CASE: UM 1910/1911/1912
WITNESS: BRITTANY ANDRUS

**PUBLIC UTILITY COMMISSION
OF
OREGON**

STAFF EXHIBIT 100

March 16, 2018

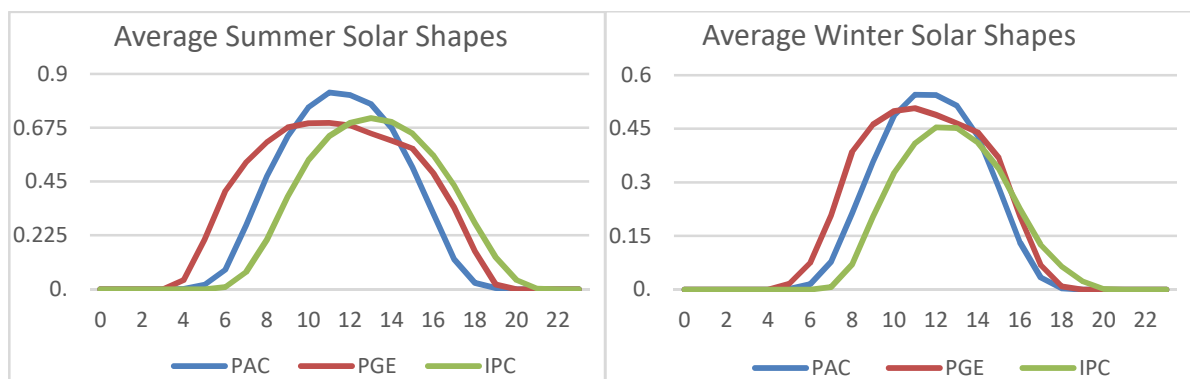
3 A. Staff provides quarterly comparisons of each utility's results in the four
 4 graphs below.
